# UNITED STATES PATENT AND TRADEMARK OFFICE

APPLICATION NO.	FILING DATE	FIRST NAMED INVENTOR	ATTORNEY DOCKET NO.	CONFIRMATION NO.
10/629,024	07/28/2003	Peter G. Webb	10003513-2	7639

<b>Office Action Summary</b>	<b>Application No.</b> 10/629,024	<b>Applicant(s)</b> WEBB, PETER G.	
	<b>Examiner</b> Christopher M. Gross	<b>Art Unit</b> 1639

### DETAILED ACTION

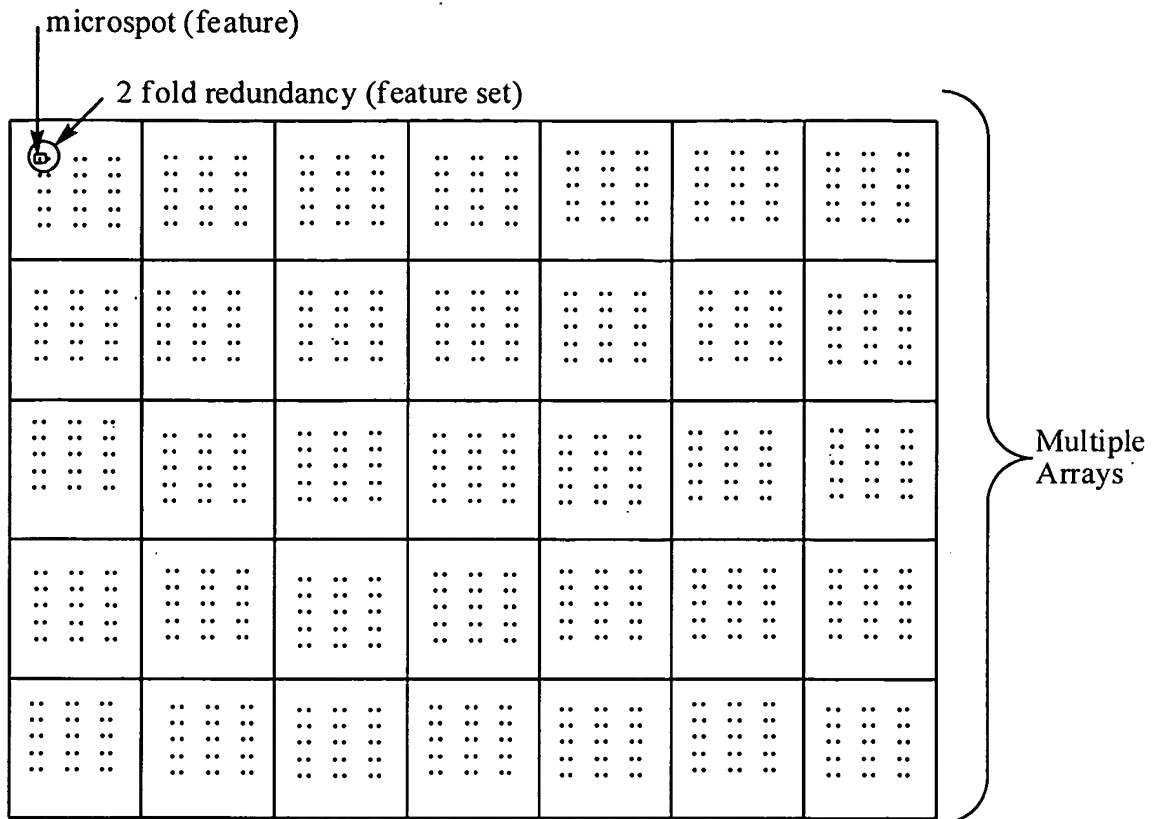
In figure 6 Gamble et al disclose a 7 by 5 array comprising a 5 by 5 neighboring feature set under construction having approximately a 2 x distance between the neighboring sets of features, reading on '[a] distance between at least two neighboring sets of features [being] greater than an average distance between features within the sets, both as measured in a same direction' of claim 17 as well as a 'a distance

between at least two neighboring feature sets [being] greater than a greatest distance separating features within the sets, both distances as measured in a same direction' of claim 26. The features have the same spacing, such as set forth in claim 37.

In so far as the processor fabricating multiple arrays on a substrate, wherein each of said multiple arrays comprises multiple feature sets, wherein each feature set is made up of multiple features," as set forth in new claim 36 as well as "fabricat[ing] an array of multiple feature sets, wherein each feature set is made up of multiple features," set forth in amended claim 17 the examiner submits that, in considering Gamble et al as a whole, figure 6 represents a work-in-progress *without* redundancy.

On the other hand, employing the 2 fold redundancy embodiment of Gamble would provide multiple arrays comprising multiple feature sets comprising multiple features, as illustrated below:
